Origination Form

Proposed Revisions to a Standard Plans Index

Originator:	Meyer, Ronald	Index Number:	700-120
Date:	6/5/2024 1:55:54 PM	Sheet Number(s):	7, 8, 10, 13, 14
E-mail:	Ronald.Meyer@dot.state.fl.us	Index Title:	ENHANCED HIGHWAY SIGNING ASSEMBLIES

ROADSIDE SIGN ASSEMBLY-4

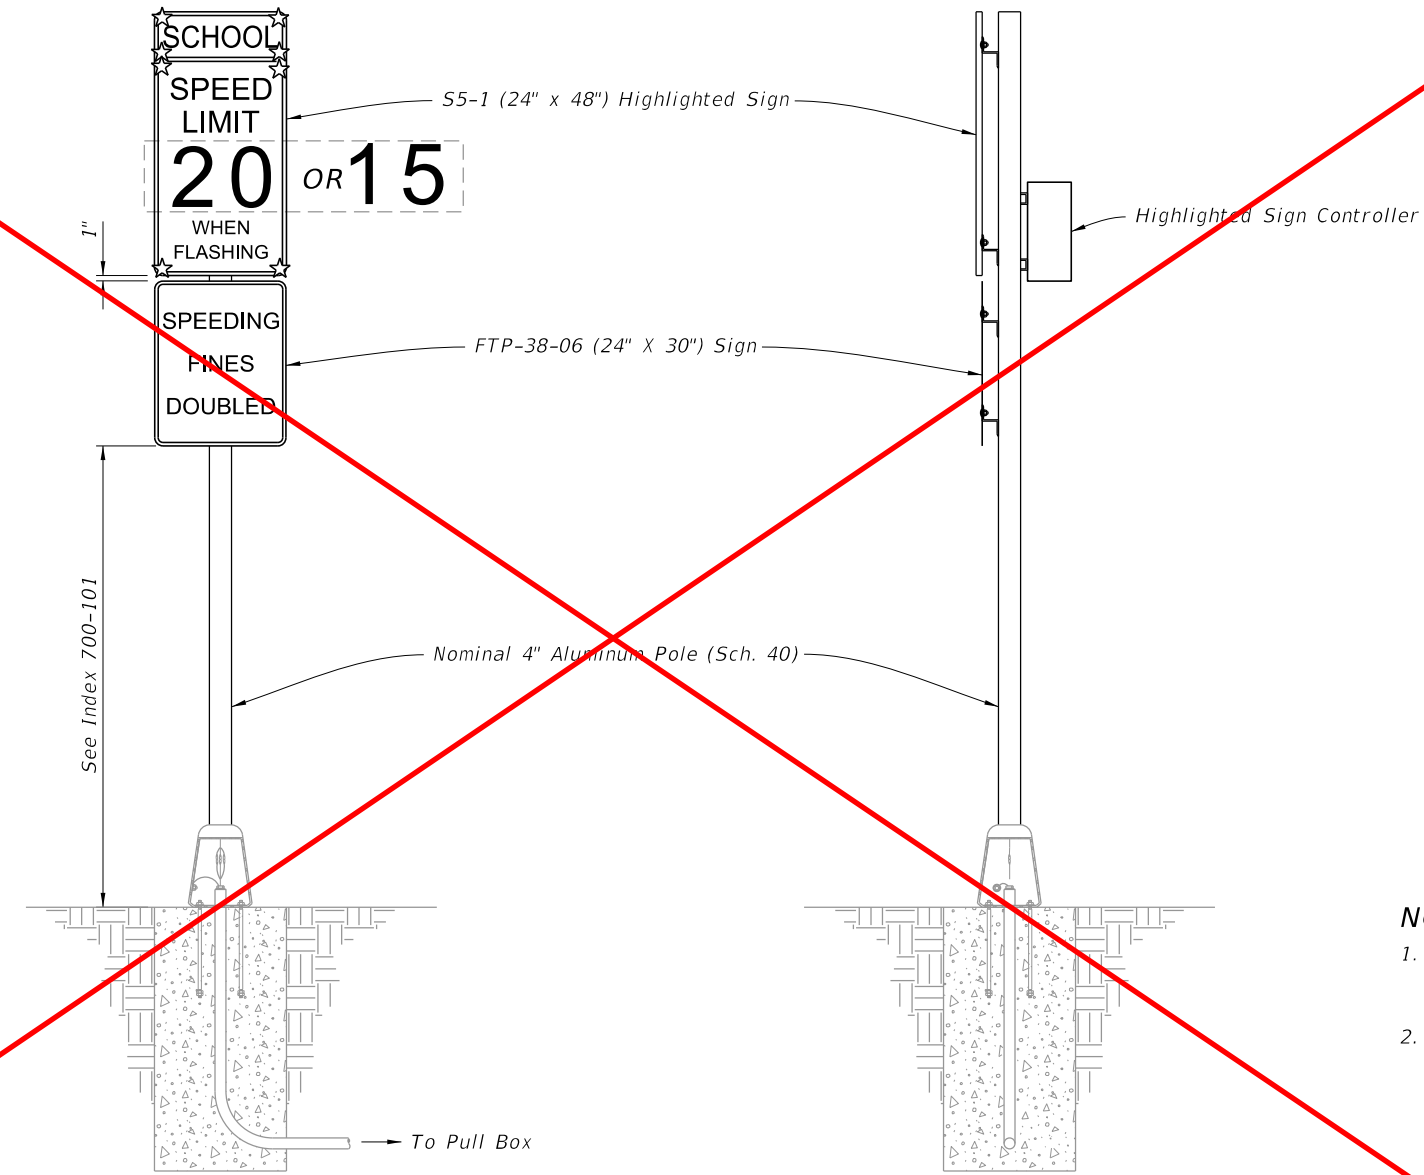
Sheets 7 and 8: The 11th Edition MUTCD, Section 2A.12 (12) states:Flashing LED units shall not be used within the legend or border of a Speed Limit sign to indicate that the displayed speed limit is in effect.

DELETED SHEET:
 The 11th Edition MUTCD, Section 2A.12 (12) states:
 Flashing LED units shall not be used within the legend or border of a
 Speed Limit sign to indicate that the displayed speed limit is in effect.

ROADSIDE SIGN ASSEMBLY-5

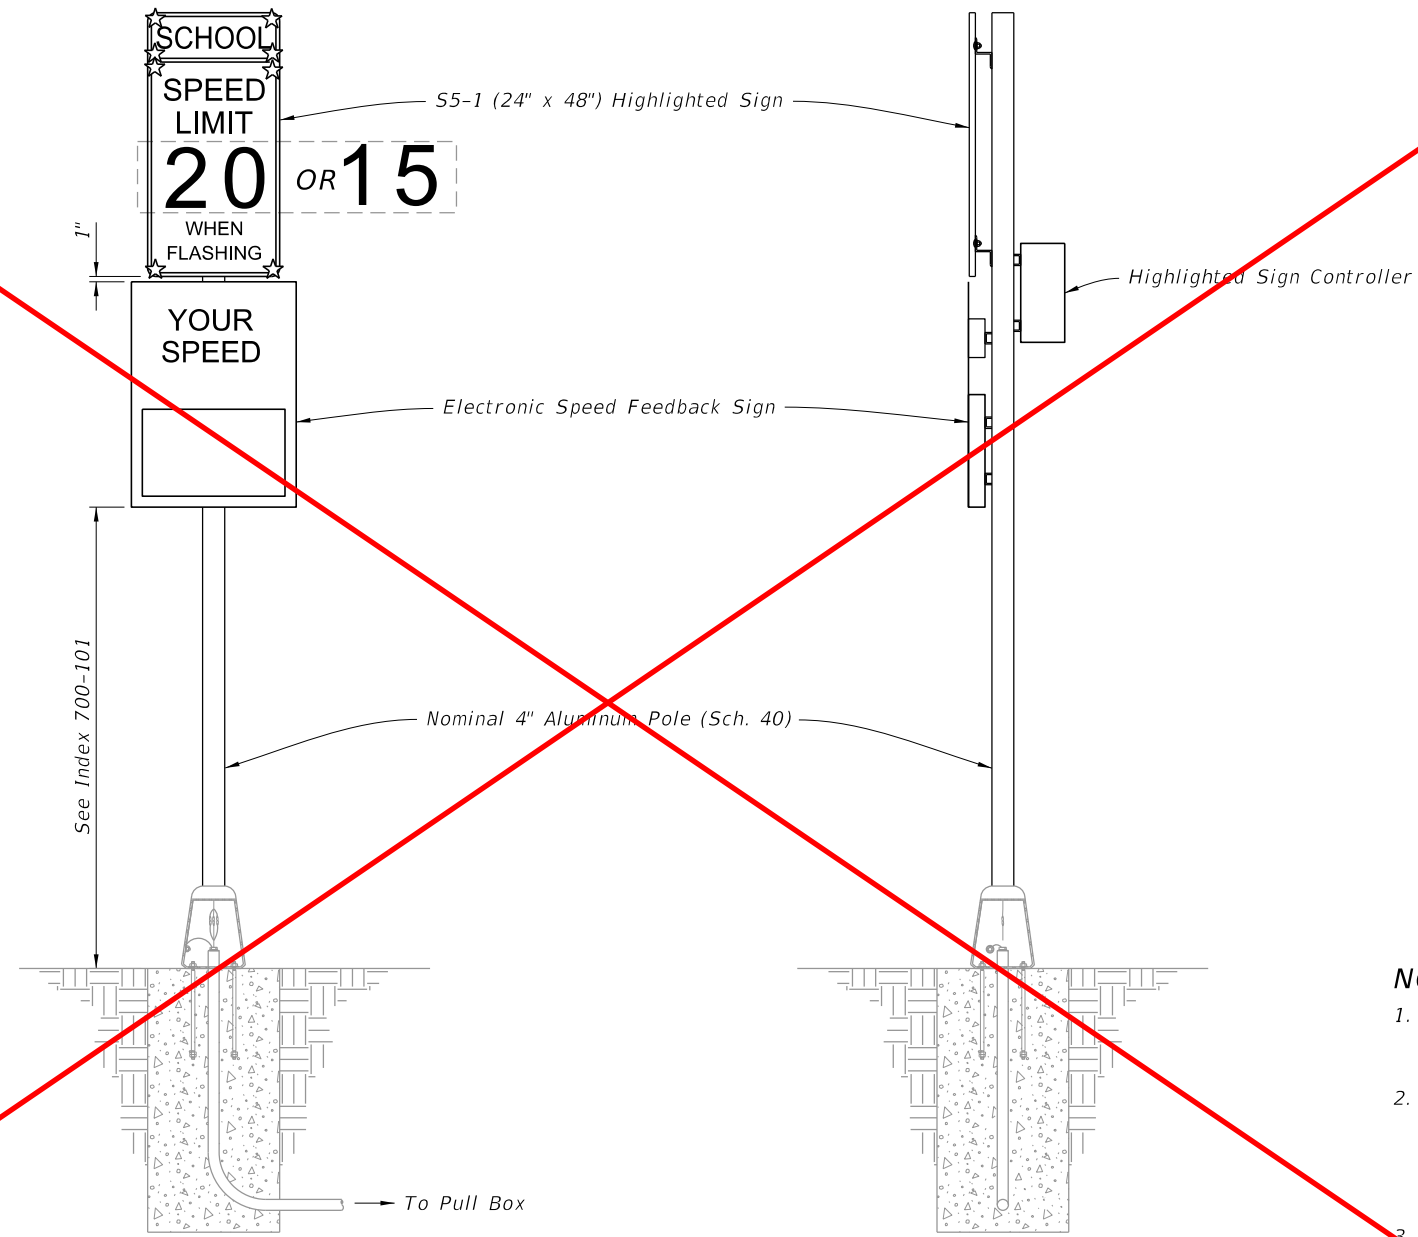
DELETED SHEET:
 The 11th Edition MUTCD, Section 2A.12 (12) states:
 Flashing LED units shall not be used within the legend or border of a
 Speed Limit sign to indicate that the displayed speed limit is in effect.

ROADSIDE SIGN ASSEMBLY-9

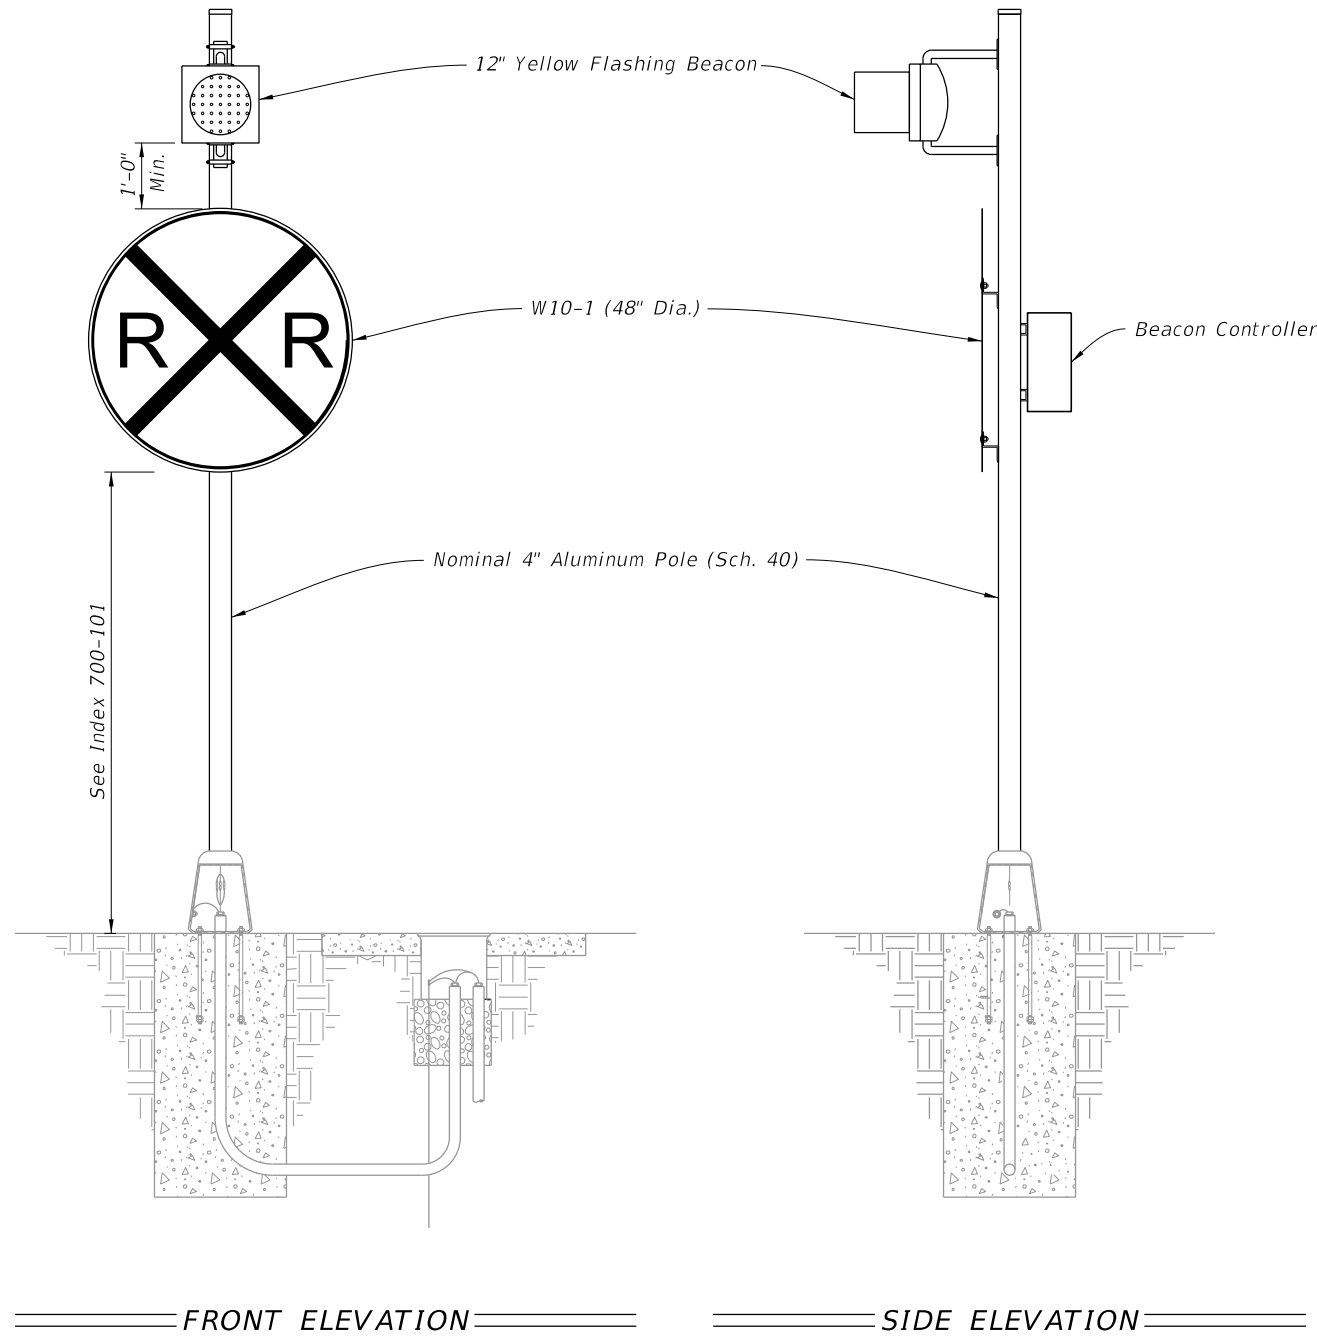
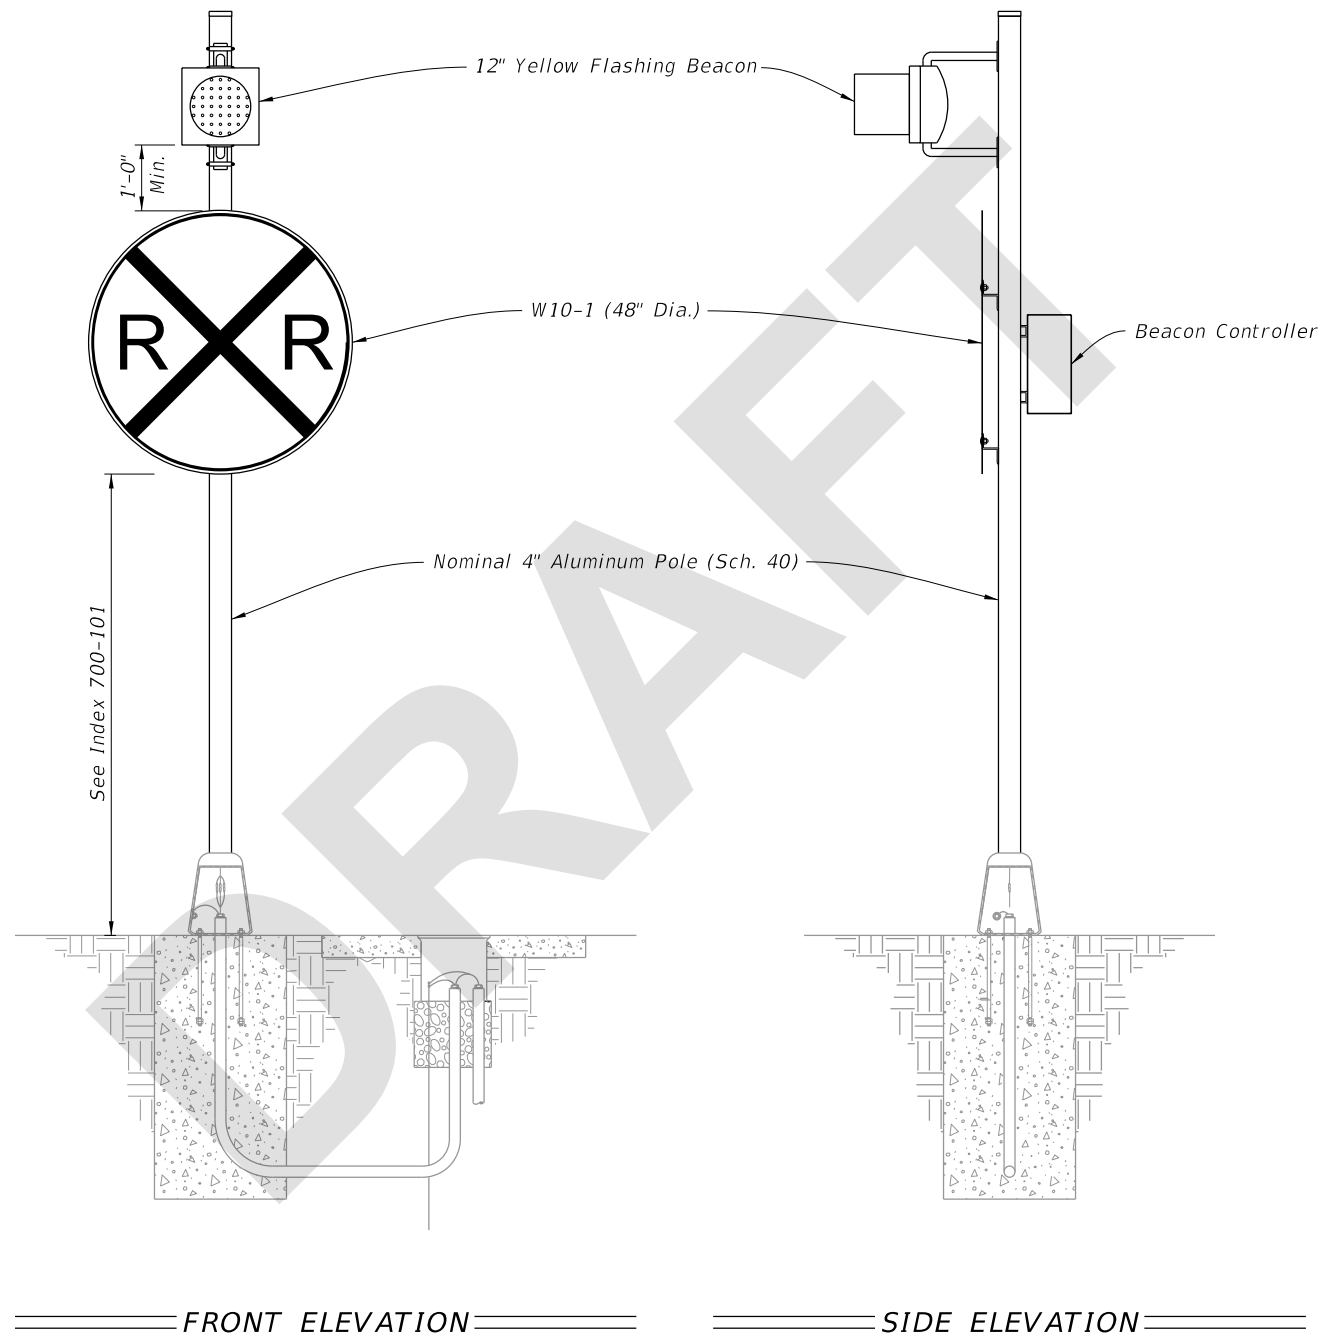
All Sheets: Renumbered Sheets
 Sheets 9-14: Renumbered Roadside Sign Assembly.
 Sheet 7: Deleted Sheet per 11th Edition MUTCD, Section 2A.12.
 Sheet 8: Deleted Sheet per 11th Edition MUTCD, Section 2A.12.
 Sheet 10: Added LEDs in the middle of each sign edge, for a total of 8 LEDs.
 Sheet 13: Added LEDs in the middle of each sign edge, for a total of 8 LEDs.
 Sheet 14: Added LEDs in the middle of each sign edge, for a total of 16 LEDs.

Sheet 10, 13, and 14: Where LED units are used along the edge of a sign, at least one LED unit shall be placed along each edge of the sign, in addition to one LED unit at each corner of the sign, so that the distinct outline of the sign shape is recognized under nighttime viewing conditions. The LED units along each side of the sign shall be spaced approximately equidistantly. For a circular sign shape, the number of LED units shall clearly form the appearance of a circle and not be perceived as some other shape.

ROADSIDE SIGN ASSEMBLY-10

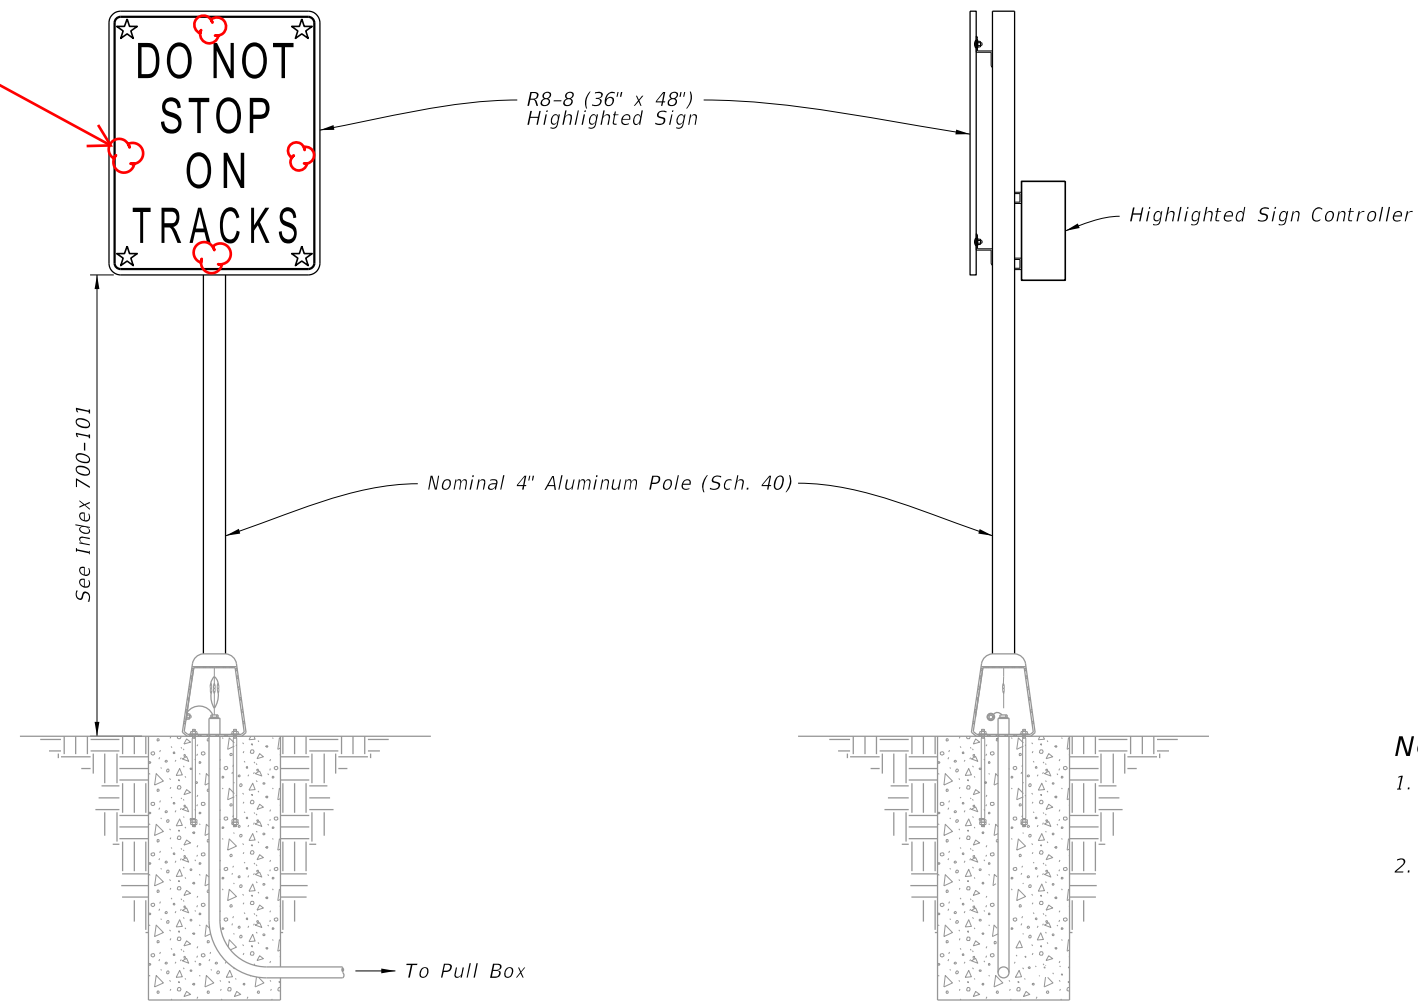
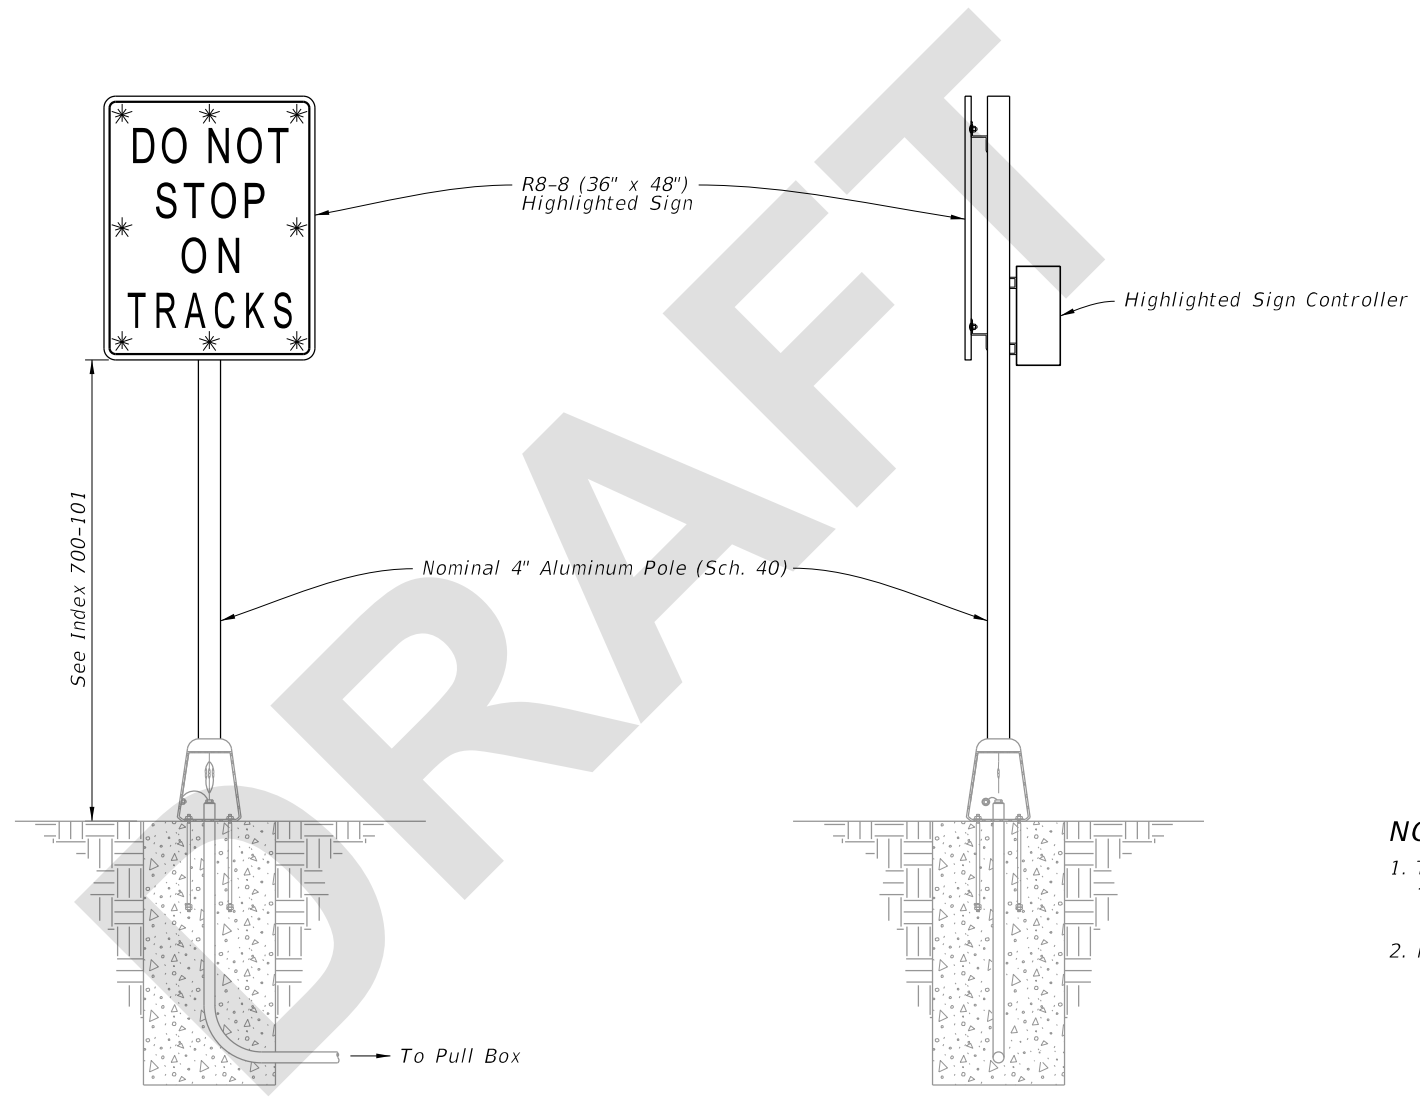
ADDED: LEDs in the middle of each sign edge, for a total of 8 LEDs.
